SERVICE INFORMATION BULLETIN

NUMBER: 07-133-18R

SUBJECT: Knock Sensor Design Change, DTCs P0327,
 P0328, P0332 and P0333

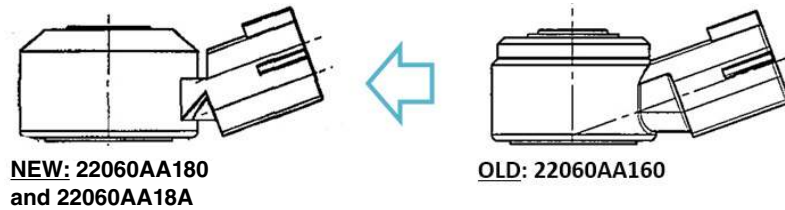
This Service Information Bulletin announces design changes to the engine's knock sensor which will help improve vehicle assembly line efficiency and increase durability. In some cases, the Check Engine light may illuminate and a knock sensor-related DTC set in the ECM memory: P0327, P0328, P0332 and P0333. The knock sensor for DIT engines is now utilized for NA engines to improve durability and resistance to heat.

The reference illustrations below show the difference between the new and the old part.

- The part number for the new knock sensor to be used on Japan-built vehicles is: **22060AA180**.
- The part number for the new knock sensor to be used on SIA / US-built vehicles is: **22060AA18A**.
